# Economic and Social Council

#### Working Party on General Safety Provisions

### **Proposal for amendments to Regulation No. 46 (Devices for indirect vision)**

#### **Submitted by the experts from the United Kingdom of Great Britain and Northern Ireland \***

Figures 8c and 8d:

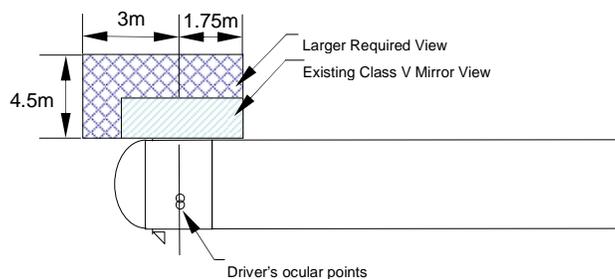
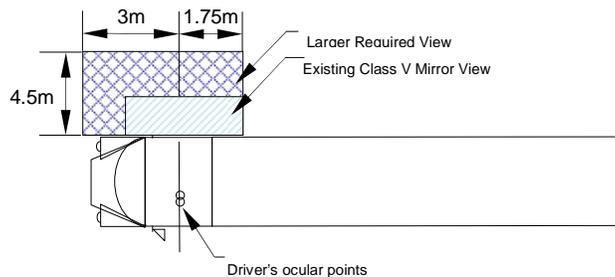
Insert new paragraphs 15.2.4.5.6. to 15.2.4.5.10. (including new Figures 8c and 8d), to read:

- "15.2.4.5.6. on the passenger side only, the field of vision shall also be such that the driver can see a flat horizontal portion of the road along the side of the vehicle which is outside the field defined in 15.2.4.5.1. to 15.2.4.5.4. but within the field bounded by the following vertical planes (see Figures 8c and 8d):

- 15.2.4.5.7. in the transverse direction, the parallel plane passing at a distance of [4.5 m\*] in front of the plane mentioned in paragraph 15.2.4.5.1.

- 15.2.4.5.8. to the rear, the plane parallel to the vertical plane passing through the driver's ocular points and situated at a distance of 1.75 m behind that plane.

- 15.2.4.5.9. to the front, the plane parallel to the vertical plane passing through the driver's ocular points and situated at a distance of [3 m\*] in front of that plane. This field of vision may be partially provided by a front mirror.

- 15.2.4.5.10. In cases where the field of vision prescribed in paragraphs 15.2.4.5.6. to 15.2.4.5.9. can be obtained without the use of devices for indirect vision then, in relation to these paragraphs, the installation of such devices is not required.
